Resource consent application – Further information request

Application number(s):	BUN60435935, LUC60435936, WAT60435937, DIS60435938
Applicant:	Precinct Properties New Zealand Limited
Address:	2 Lower Hobson Street, Auckland Central, 1010 204 Quay Street, Auckland Central Road – Lower Hobson Street, Fanshawe Street, Sturdee Street and Custom Street West
Proposed activity(s):	Demolition of the Downtown Car Park building and associated structures including the removal of the car park ramp and pedestrian footbridge to Fanshawe Street, and the pedestrian footbridge to 204 Quay Street (and associated stair access). Comprehensive redevelopment of the site to deliver a mixed use precinct comprising of three podiums providing for retail, food and beverage and office uses, connected through the city block to Lower Albert Street from Lower Hobson Street with a central public open space. Construction of two towers above podiums 1 and 2 to accommodate a mix of office activity and residential units reaching 227m and 168m in height respectively. Demolition and construction is anticipated to take up to seven years. A service lane connecting Custom Street West and Quay Street and associated lands

Image 1: Secure line indication

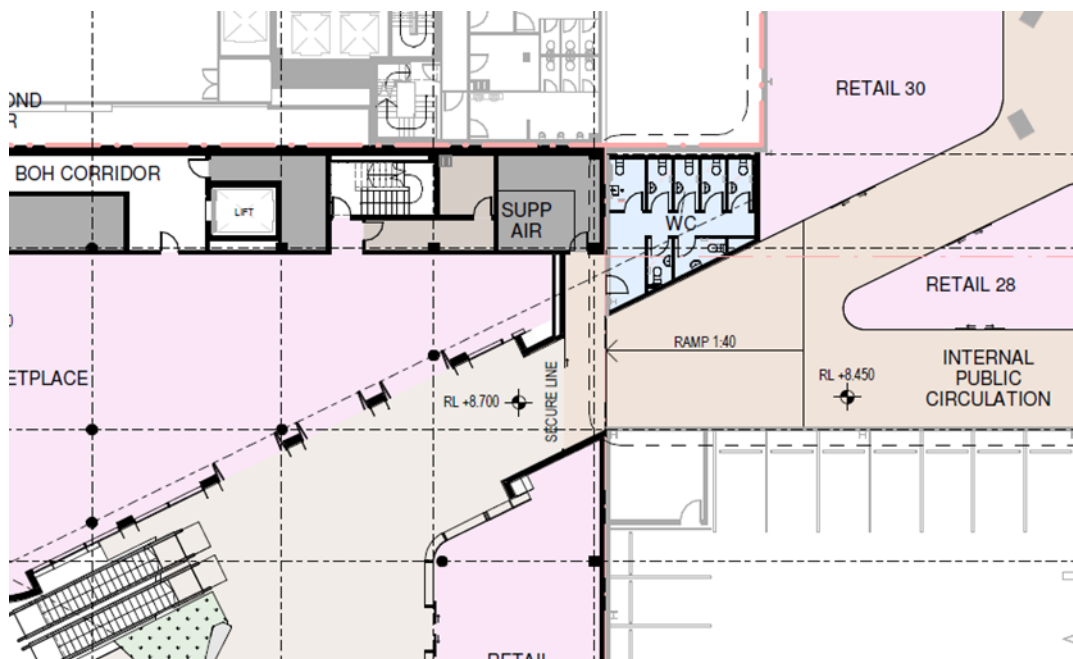
10. Page 18 of the AEE describes the Te Urunga Hau (The Urban Room). It describes this to be open 24/7 with the exception of the existing through-site link through the HSBC building which will only be open during business hours. See Image 1 below that indicates the position of the ‘secure line’. Please can the business hours be confirmed so that the degree of permeability and access is understood, including the hours of availability of the proposed public toilets, which are located on the opposite side of the secure line. These hours should match the operating hours of the proposed retail and food and beverage uses as indicated in the documentation.

Figure 1. H8.6.24.1 Maximum tower dimension standard.

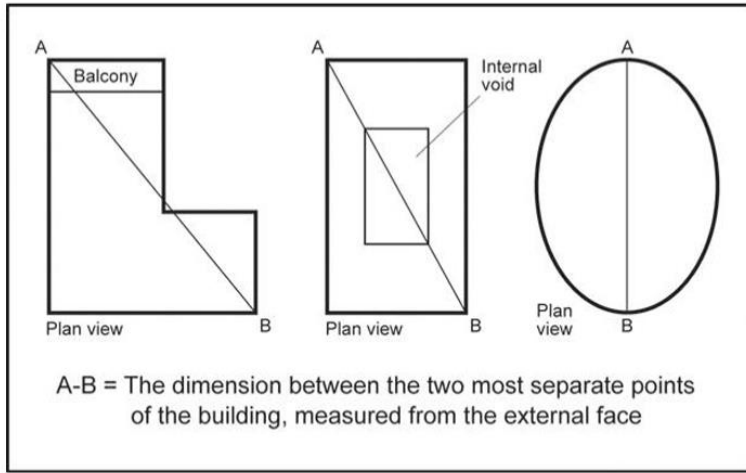
57. Maximum tower dimension: Pages 37-38 of the Urban Design Assessment report, state the diagonal dimension of 50.64m for Tower 2. However, it should be measured from the most separate points as shown in Figure H8.6.24.1 below, which is the western façade of the building, which is 50.95m. This additional dimension may seem minimal but the western façade presents some of the most imposing architectural forms.
- Please can the Urban Design Assessment, Rules Assessment and AEE be updated to state the correct dimension.
 - The Urban Design Assessment report does not include Tower 2 in this specific section and concentrates only on T1. Please can the Urban Design Assessment Report be updated to provide assessment of Tower 2 for this Standard.

Figure 2 – Figure 2.30 from the Urban Design Assessment.

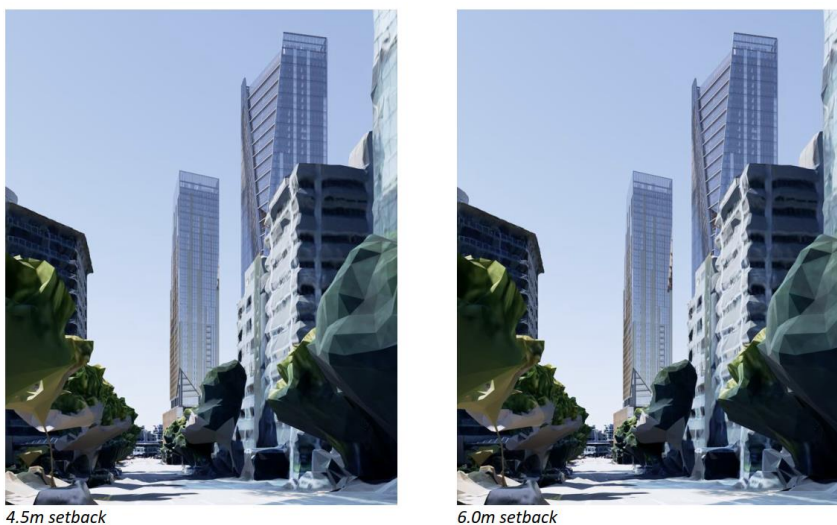
58. **Tower setback:** For Tower 2, a comparative diagram was included on page 40 of the Urban Design Assessment report with two versions, one with a 4.5m setback and the other with the required 6m setback from Lower Hobson Street. However, the chosen view angle is quite distant to assess the street experience, and the resolution and the level of detail of these diagrams are quite low (Figure 2 below illustrates this). To better inform the assessment of effects, please provide the following to demonstrate how the proposal achieves a consistent human-scaled edge to the street:

- i. a more detailed analysis regarding this reduced setback be provided; and
- ii. additional model render views at a higher resolution based on the series of locations identified in Figure 3 below;

Figure 3. Requested view locations related to tower setback comparison.

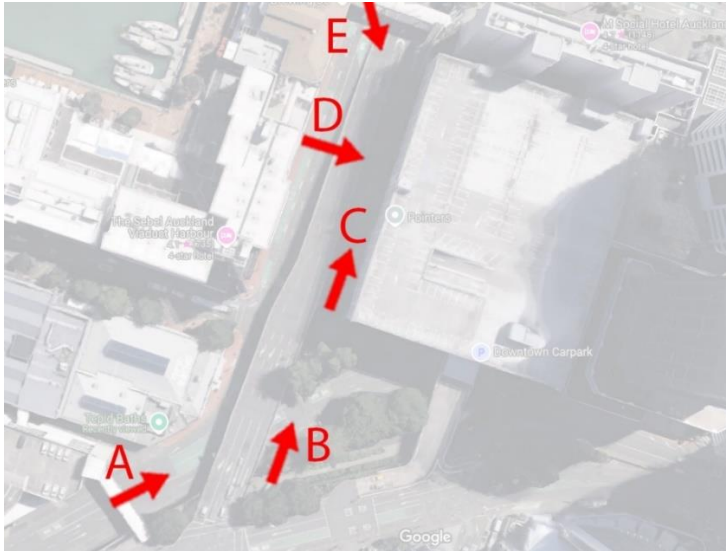
14. View from corner of Hobson St and Fanshawe St looking north-east towards the site. Note – view should be amended to represent human scale.

Figure 6. Requested detailed sections.

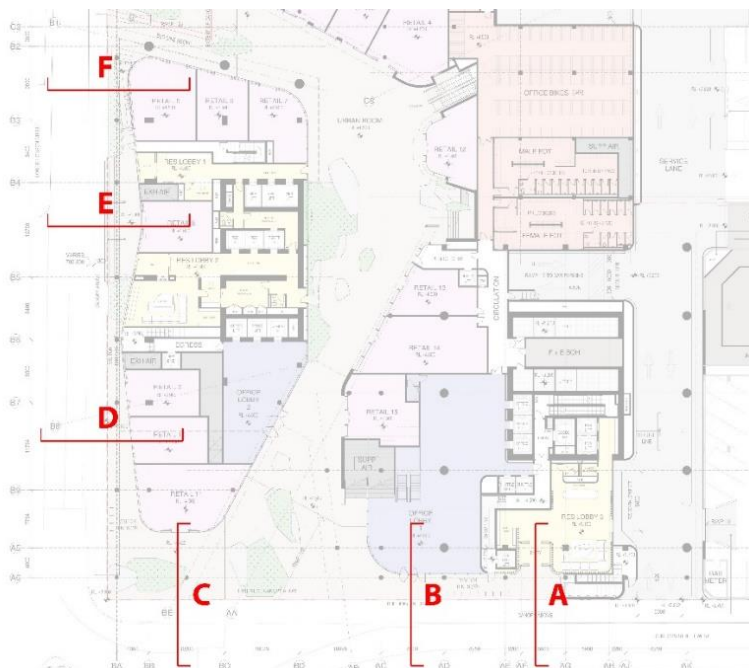
- b. Various detailed rendered sectional views have been produced for the internal laneways (pages 28-29 of the Architectural and Landscape Report by Warren and Mahony). Please provide sectional drawings with a similar level of detail at a scale of 1:100 or a similar scale for the street interfaces to Lower Hobson Street and Custom Street West (Requested detailed sections A-F in Figure 6 below) to illustrate the relationship of the proposed buildings with the street including the verandah and canopy provision. Please include the adjacent road reserves, pedestrian footpaths, kerb lines and detailed dimensions indicating space widths and heights for canopies and verandahs. Please include people in the drawings to illustrate the interface's relationship to users and extend of cover provided.

- c. **Non-s92 Query:** During the pre-application meetings, the applicant had previously stated that the verandah standard would be met for the final application, however, no verandah is provided along the Customs Street West frontage and at Lower Hobson Street a 1.8m wide verandah is provided (it is further noted that a 3.0m verandah was wind tunnel tested to Lower Hobson Street). Note also that a verandah cover is required for corner sites (refer Figure H8.6.26.1 Chapter H8 of the Auckland Unitary Plan). In this context, please can it be clarified what led to the decision to not include a verandah in the final version? Along the Custom Street West interface, were verandah options tested by the applicant, including Hobson Street corner and the Aon building frontage?

Figure 1 Figure 2

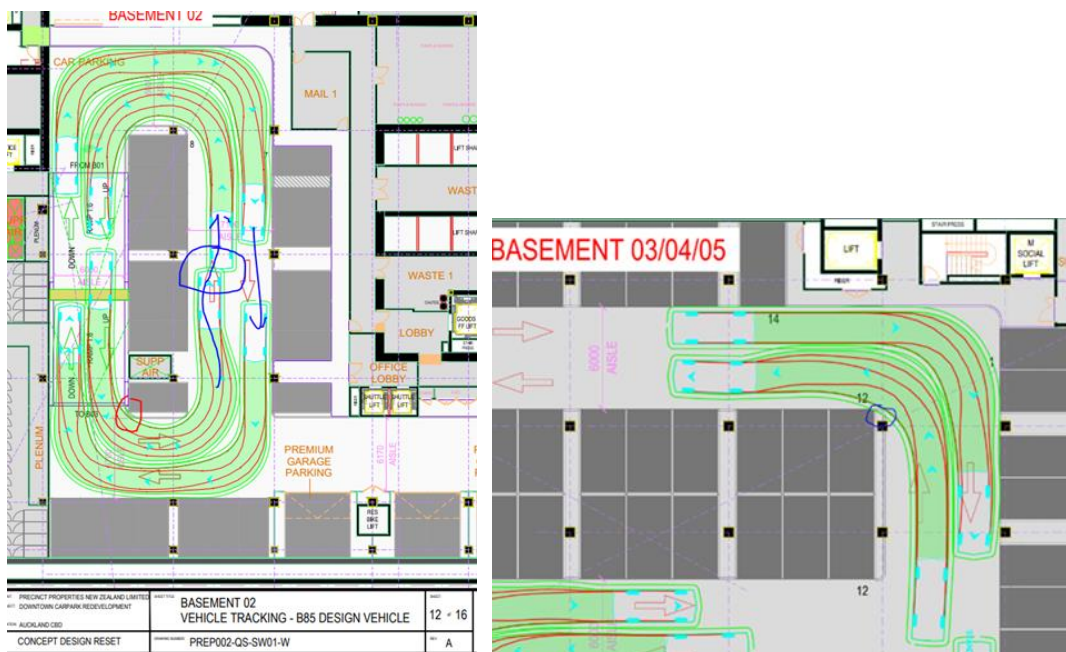
136. Access and Maneuvering (E27.6.3.3). The Vehicle Tracking assessments are provided as Appendix E of the Traffic Report. Sheet 12 of 16 Basement 02 Vehicle tracking – B85 Design Vehicle (Drawing number: PREP002-QS-SW01-W Rev A) with snip copied below (Fig 1) shows a clash with a structure (identified with the red circle). The blue annotation below illustrates a segmented / non-continuous tracking curve. Please provide tracking curves that are continuous and do not clash with structures.

137. Sheet 14 of 16 Basement 03/04/05 Vehicle Tracking – B85 Design Vehicle (Drawing number: PREP002-QS-SW01-W Rev A) with snip copied above (Fig 2) shows the tracking curve clearance clashing with a structure. Please amend the tracking curves or identify design changes that provide mitigation for this clash.
